PLOT C

DESIGN AND ACCESS STATEMENT
ADDENDUM

Date	Issue	Notes
12/09/2025	P01	First Issue

Key Plan

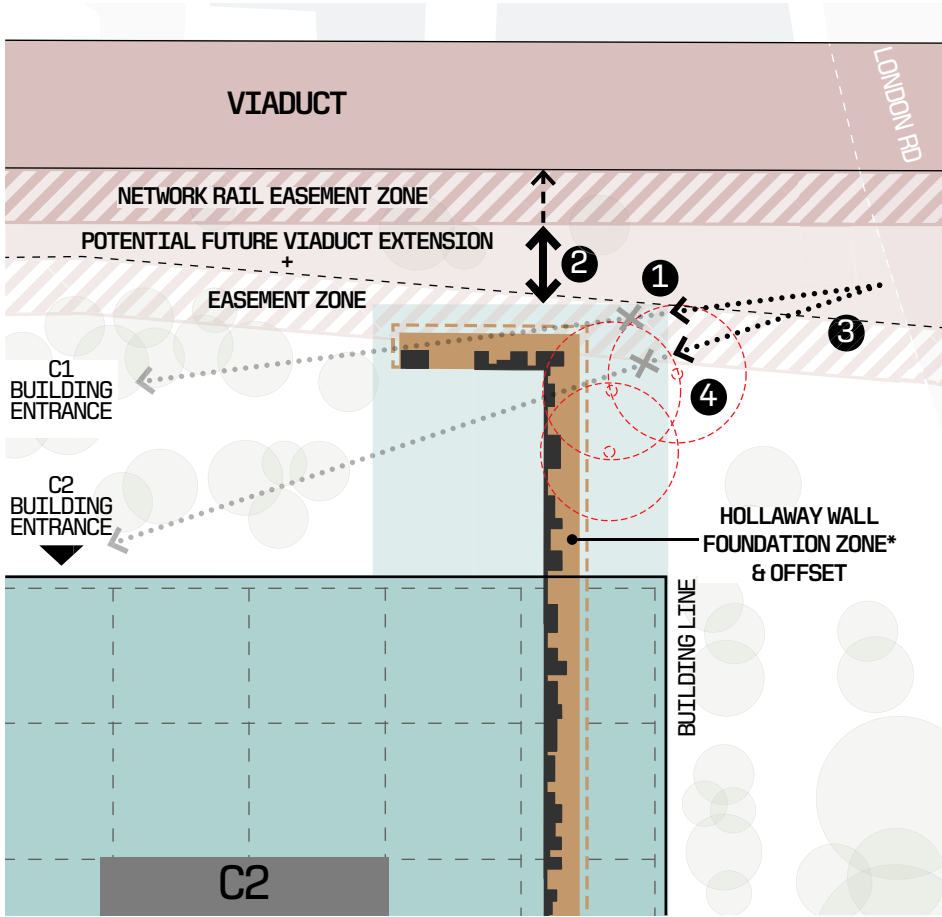
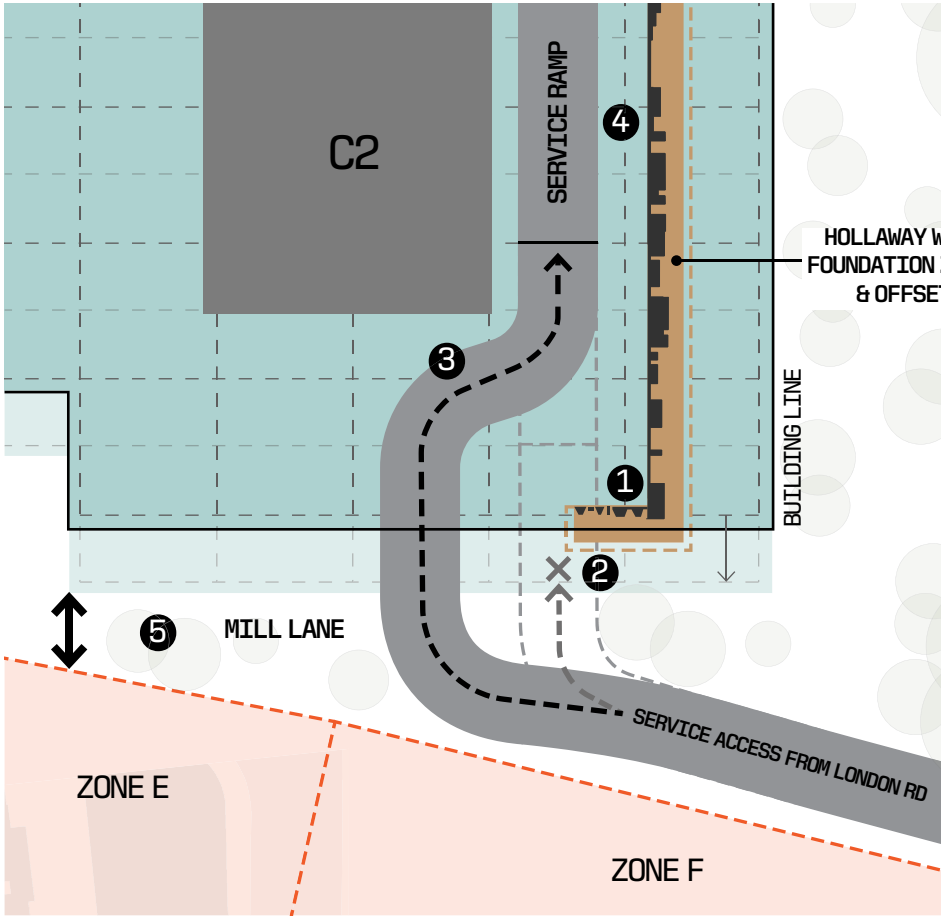
The following considerations and constraints have been considered in determining that fully encapsulating the northern section of the Hollaway Wall is not compatible with the objectives of the project brief and SRF:

The following considerations and constraints have been considered in determining that fully encapsulating the southern section of the Hollaway Wall is not compatible with the objectives of the project brief and SRF:

- 1 The proposed location of structural columns and foundations coincides with the southern return of the wall. A number of options for the buildings’ footprint and relationship to the wall were considered, with the proposed arrangement informed by the following factors, as illustrated further on pages 27 & 76 of the Design and Access Statement.

- 3 Retaining the southern return in its current location and extending the building footprint severely impedes vehicle access to the service tunnel, extending the route further into the public realm along Mill Lane and involving a series of tight turns, making it unviable for large goods vehicles.

Proposed amended typical C1 western facade bay

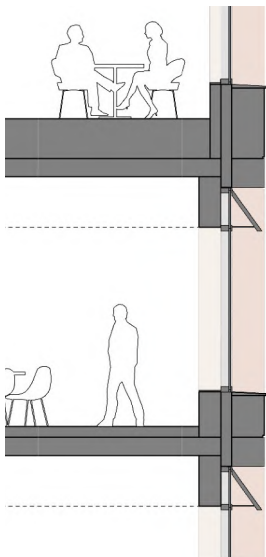
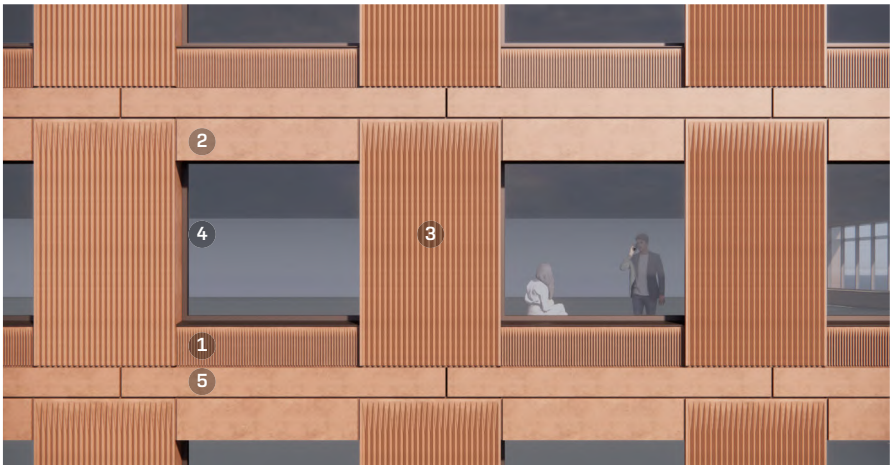
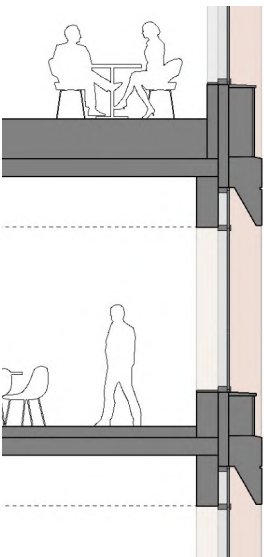
Facade details have been refined through continued regular consultation with MCC officers, addressing comments received expressing a preference for spandrels to east and west elevations to be recessed, and for ventilation requirements for the proposed local MVHR systems to be integrated into the geometry of the precast facades.

A splayed lintel detail has been developed as part of the precast concrete panel design, in lieu of the metal fascia panel included in the previously submitted proposals.

Precast spandrels to east/west facades have been recessed in response to comments received from MCC regarding the articulation of openings. This more frame-like expression is strengthened by the application of a fine gauge cast profile to spandrels, providing texture and shadow that increases their contrast to the flush outer frame of piers and lintels.

- 1 recessed profiled pigmented precast concrete spandrel with top feathering detail
- 2 smooth pigmented precast concrete splayed lintel
- 3 profiled pigmented precast concrete pier with top feathering detail
- 4 fixed clear glazing with framing
- 5 continuous smooth pigmented precast concrete lintel
- 6 integrated window seat

Proposed amended typical C1 southern facade bay

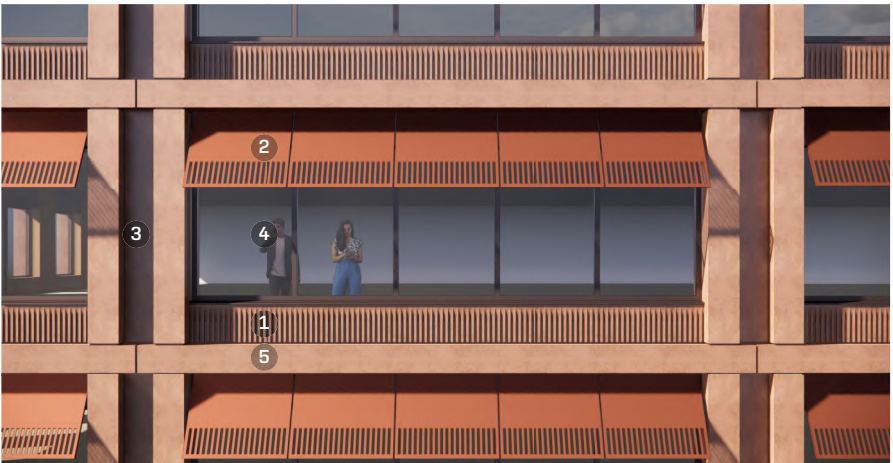
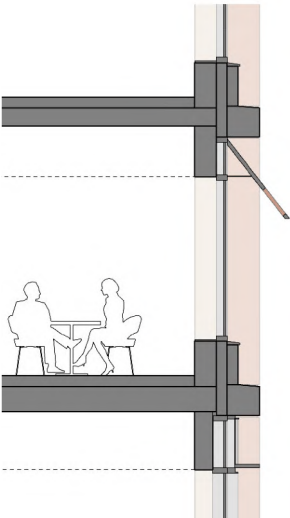
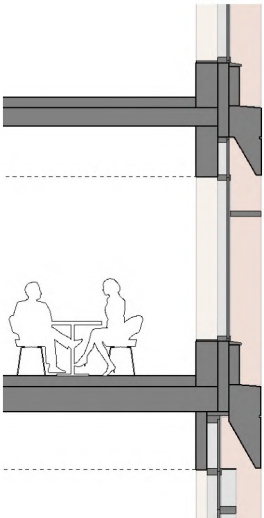
The north and south facades of typical office levels have been adjusted to incorporate the revised splayed precast lintel detail, providing ventilation requirements while concealing performance micro-louvres behind. The recessed spandrel has also been refined with a similar fine gauge cast profile to east and west facades, creating a cohesive composition of finishes across both facade types.

Responding to comments from MCC officers regarding the integration of solar shading elements required to south facades, a rationalised 'light-shelf' element has been integrated into the aluminium glazing system, replacing the extended angled metal brise soleil included in the previously submitted proposals.

The light-shelf is positioned at an optimal height for passive shading while providing improved views out and reflecting natural daylight inside, further optimising the internal office environment.

- 1 recessed profiled pigmented precast concrete spandrel with top feathering detail
- 2 smooth pigmented precast concrete splayed lintel
- 3 smooth pigmented precast concrete double pier
- 4 fixed clear glazing with framing and integrated light shelf
- 5 continuous smooth pigmented precast concrete horizontal
- 6 integrated window seat

F Renold Podium - east facing entrance area

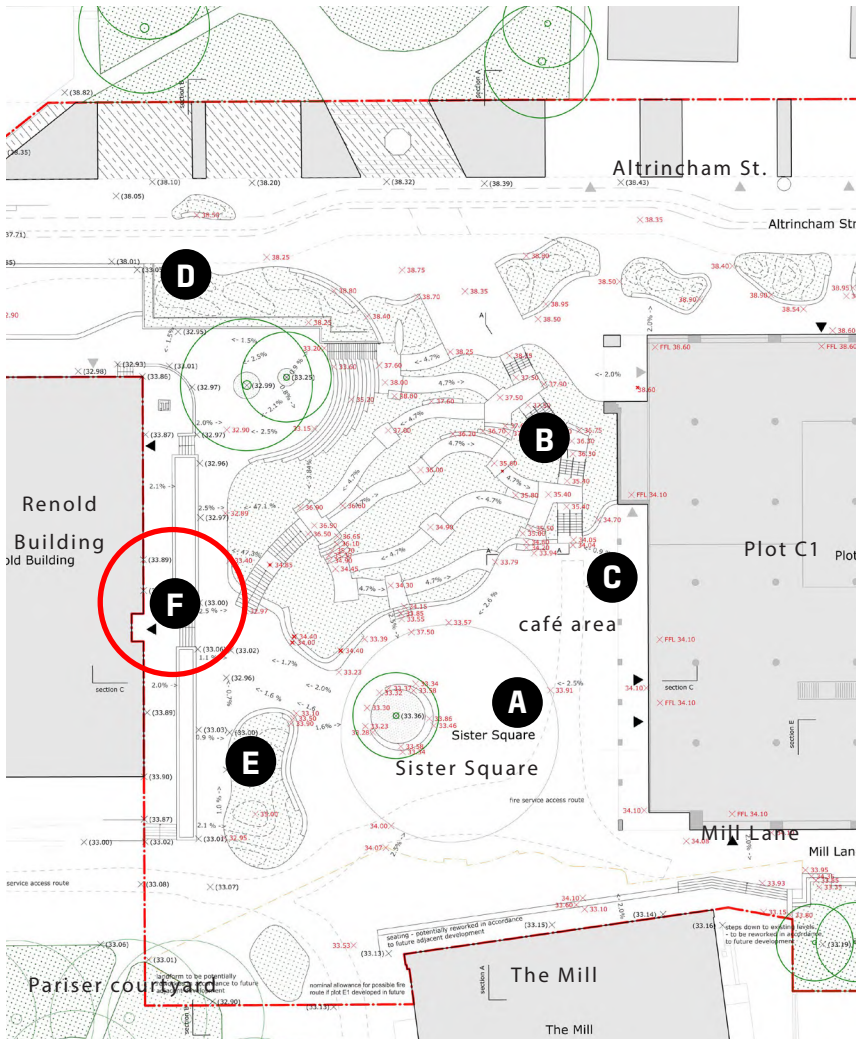
Following the listing of the Renold Building and the retention of the external podium, an additional sub-character zone (F) has been added to the Sister Square proposal - the Renold Podium along the east facing facade of the Renold building.

The existing Renold podium, planters, stairs and retaining wall are kept, to maintain the buildings presence and direct access to Sister Square.
